MASTER DEVELOPMENT PLAN  
 for  
 GORDON'S GROVE

Re: Gordon's Grove

**MDP # 007-06**

The City Staff Development Review Committee has reviewed Gordon's Grove Master Development Plan M.D.P. # 007-06. Please find enclosed a signed copy for your files. Your plan was accepted however please note the following:

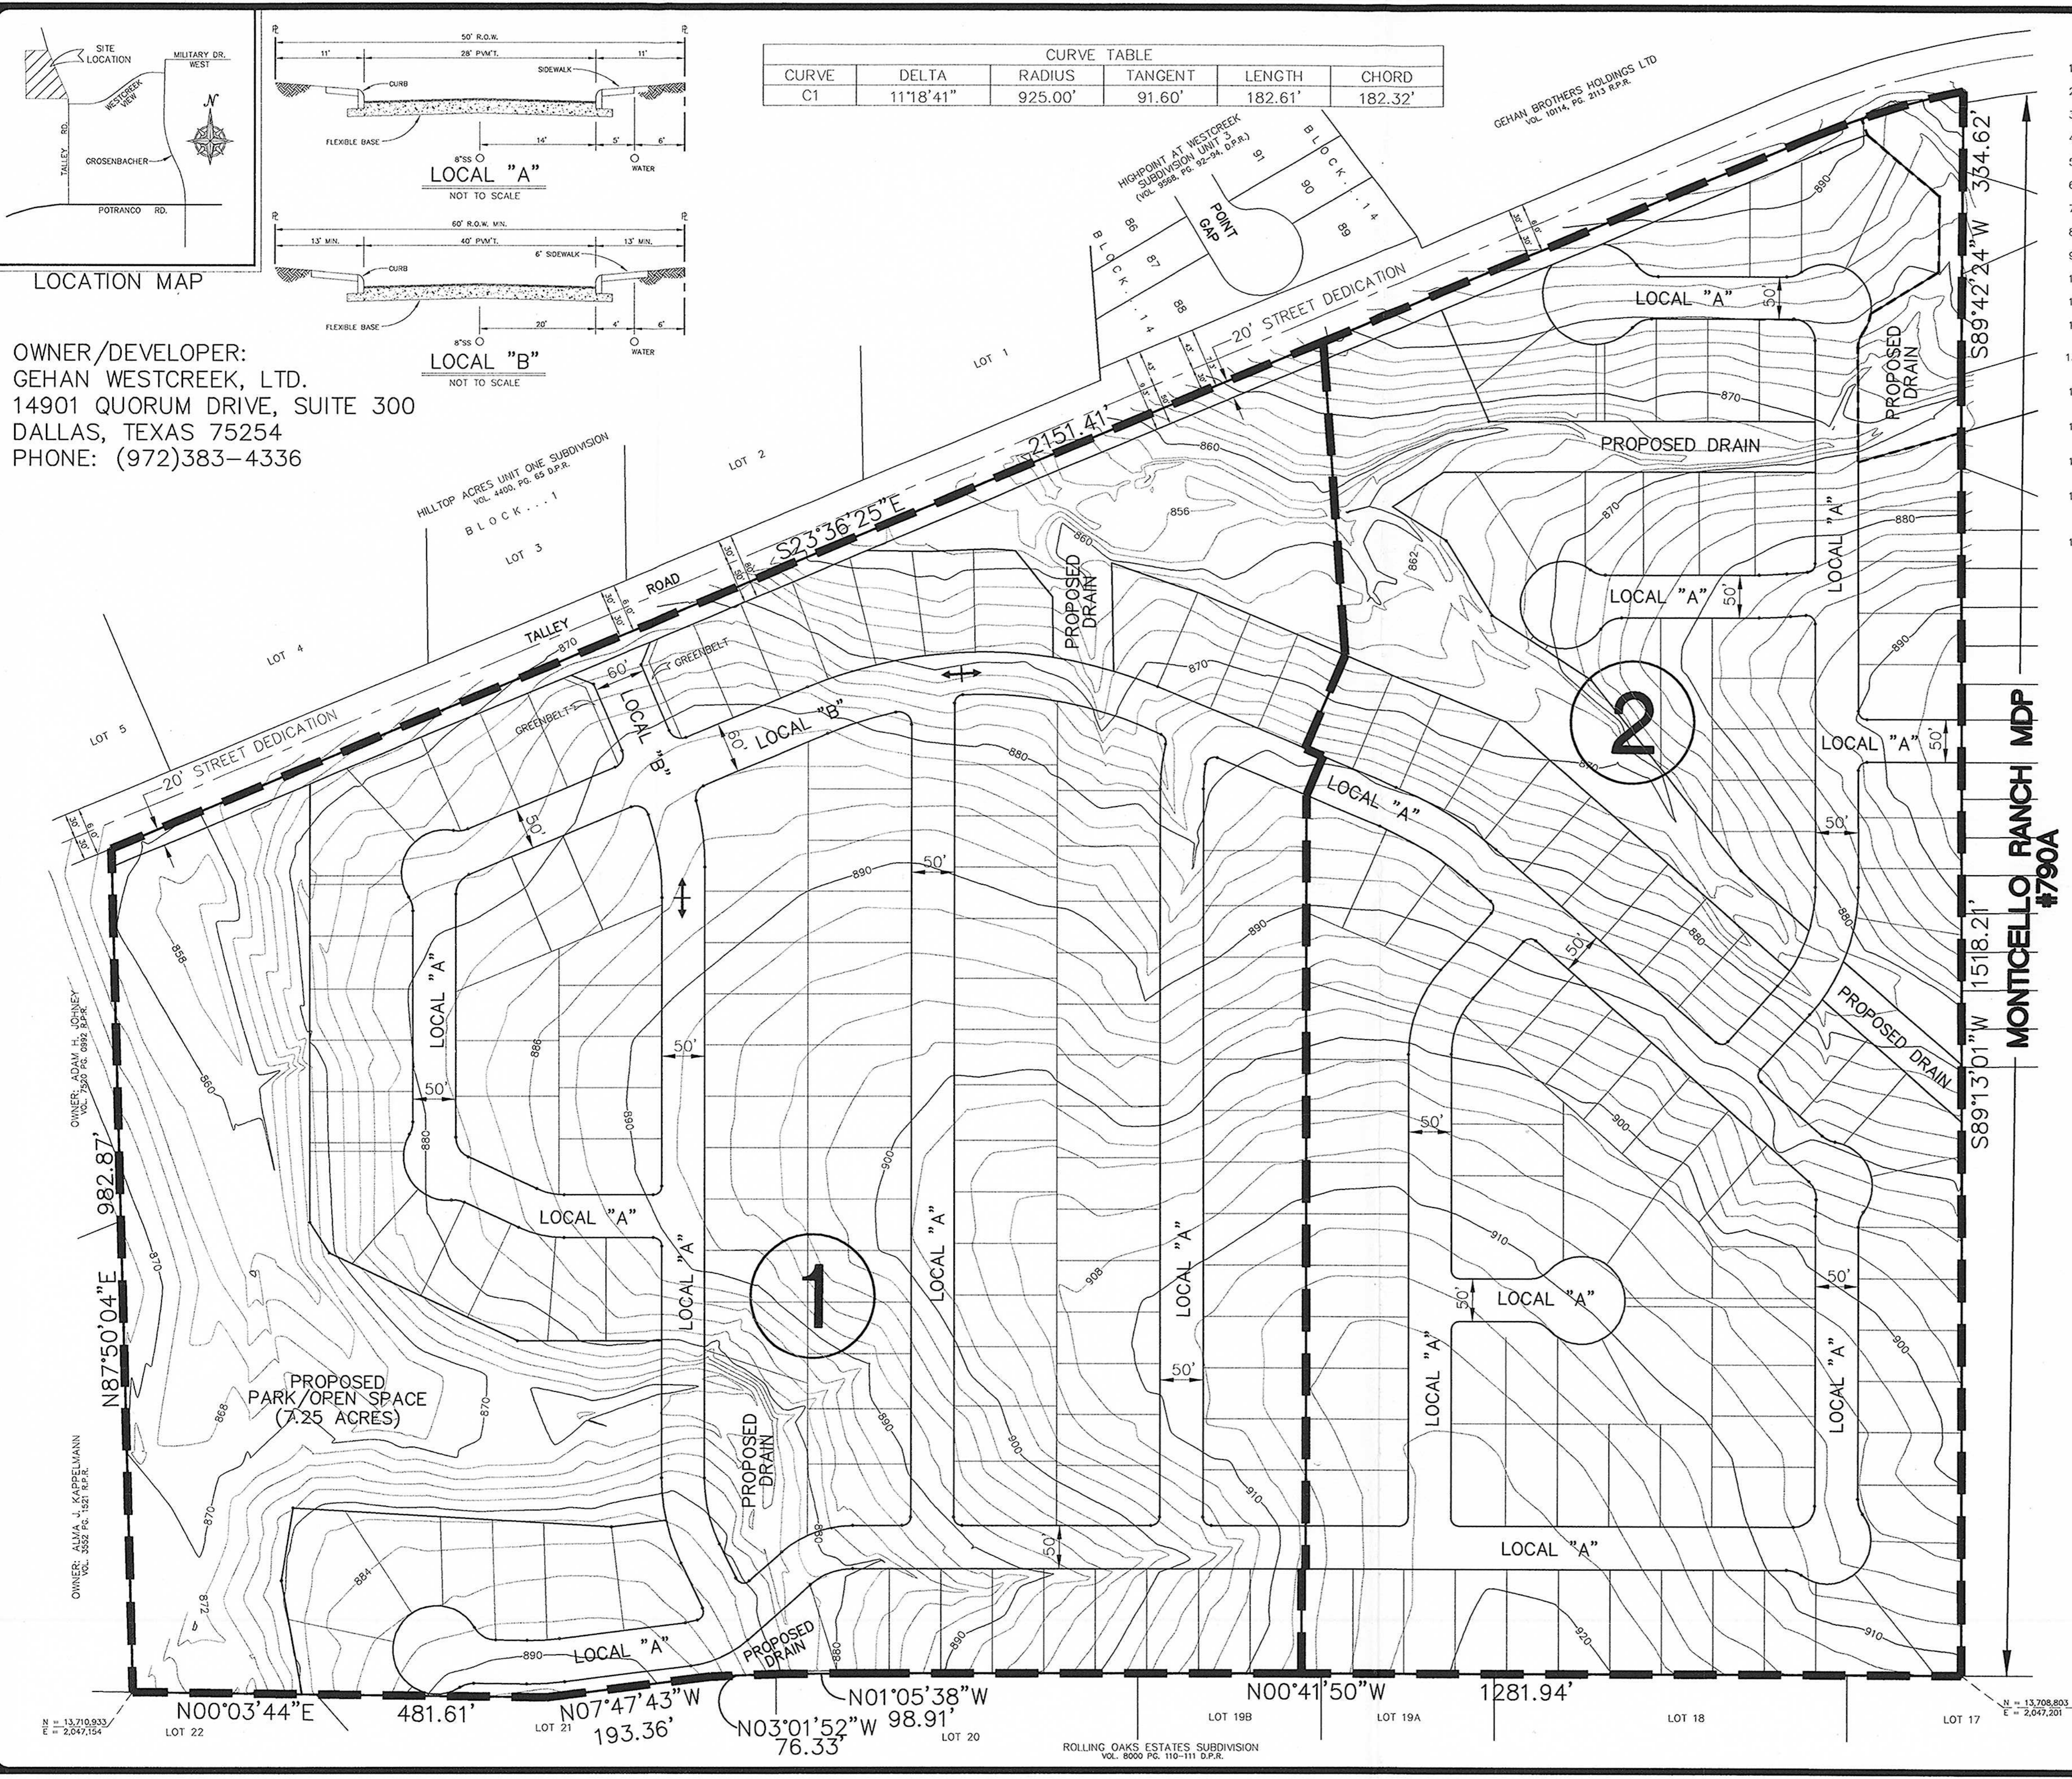
- In consideration of public safety and convenience, excessive grades by reason of topography should be avoided in street layouts and arrangements.
- Any access and R.O.W. issues along state facilities will need to be resolved with the **Texas Department of Transportation (TXDOT)**. For information about these requirements you can contact TXDOT at 615-5814.

- **Historic** indicates that
  - The Texas Site Atlas indicates that no archaeological sites have been previously identified within the above referenced property. However, the project area is within the Medio Creek drainage area, an area known to contain sites and there is a **high probability** that the property may contain sites, some of which may be significant. Thus, before any work that might affect any sites is begun, we recommend that a qualified professional conduct an archaeological investigation of the property.

- **DSD – Traffic Impact Analysis & Streets** indicates that the developer shall be required to provide a left turn lane from northbound Talley Road to serve left turn movements into the subdivision based on the TIA turning movements. Storage length of 200 feet with 100 foot taper.

- **Trees** approves with the following conditions:
  - 2003 Tree Preservation ordinance standards per UDC 35-523 – a Master Tree Permit has been issued for this project based on the Tree Canopy method. No additional

affidavit/permit fees will be required for platting or building permits on this project, but plats will be subject to a \$75 review fee.

- Streetscape Standards per UDC 35-512 – Talley Road requires streetscape on existing ROW (it appears that preservations of existing trees may fulfill this requirement if they are on the ROW thus avoiding the planting and irrigation of new streetscape trees). The new ROW on the unmanned section of collector into the subdivision will require streetscaping as well
- Please keep copy of approval and stamped preservation plan on site during site work. A copy of the stamped plan is available at the second floor reception of Development Services
- It will be expected that you will plat all of the property depicted in your Master Development Plan (M.D.P.) to include floodplains, drainage areas and open space.
- I would encourage you to work closely with the school district, so that they can plan accordingly.
